**FORMER LANDFILL
LF-024**

RECORD OF DECISION

**RESPONSE TO NYSDEC COMMENTS
ON THE DRAFT RECORD OF DECISION FOR LF-024**

**RESPONSE TO EPA COMMENTS
ON THE DRAFT RECORD OF DECISION FOR LF-024**

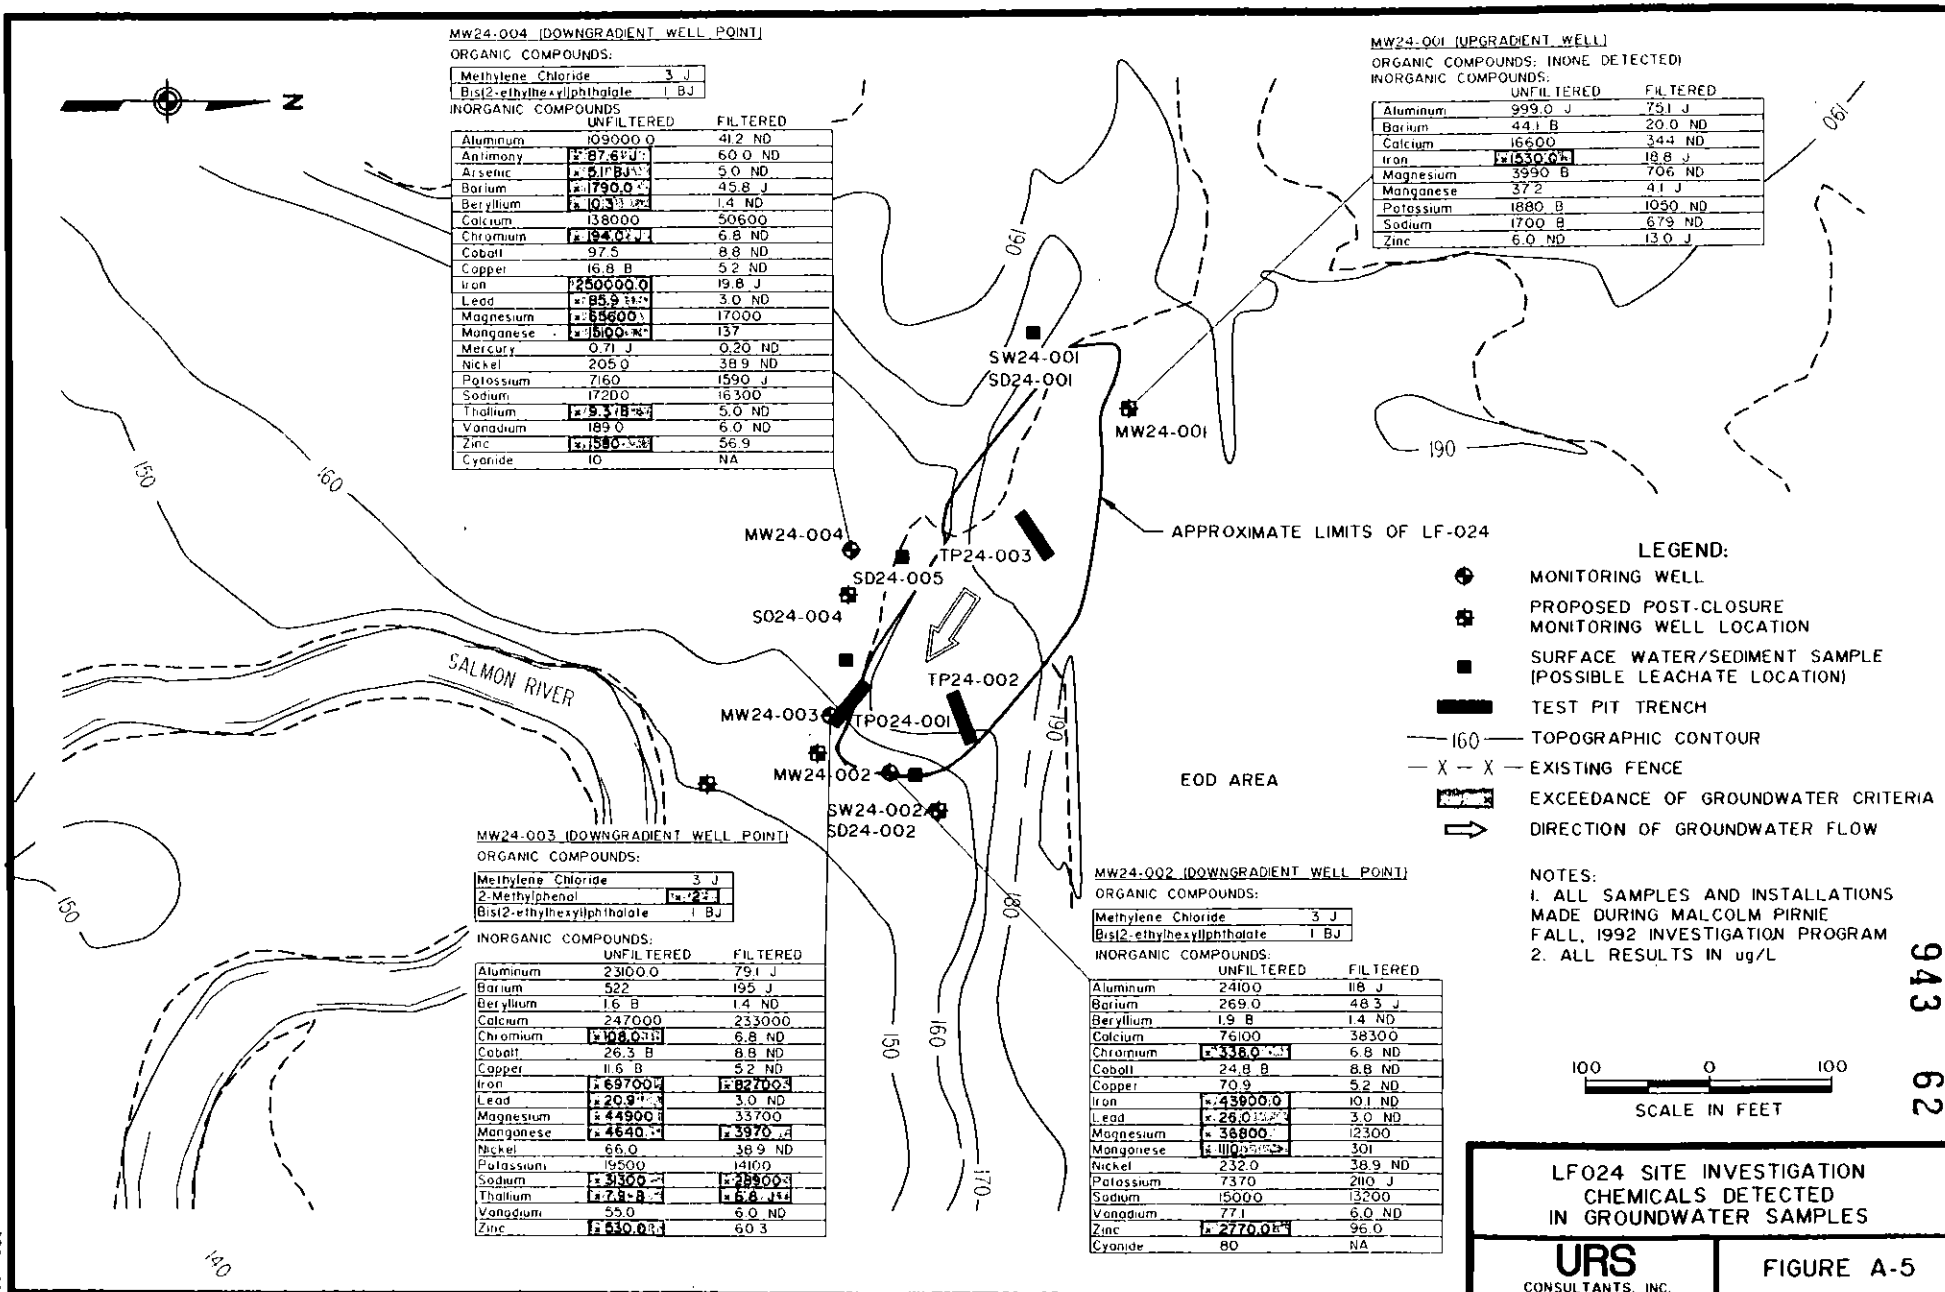
Figure A-2: This figure differs slightly from the same figure in the Proposed Plan. The results from MW24-003 and MW24-004 have been switched with each other. Also, the results for MW24-002 have changed. Which are the correct versions?	The correct version is the latest version (i.e., 12-2-96) which appeared in the draft final proposed plan. The draft final ROD will include the revised figures.
Figure A-3: This figure differs slightly from the same figure in the Proposed Plan. The results for many of the metal in TP24-003 in the ORD have a number in addition to an "ND". The same results in the Proposed Plan simply had "ND", without a number. Which is correct? What is the significance of the number?	See above explanation. The numeric values which appear with "ND" (i.e., non-detect) indicates the equipment detection limit for the respective analyses. Standard practice is to drop the detection limit value and report the analyte as a non-detect on analytical summary tables since an actual quantity was not reported.
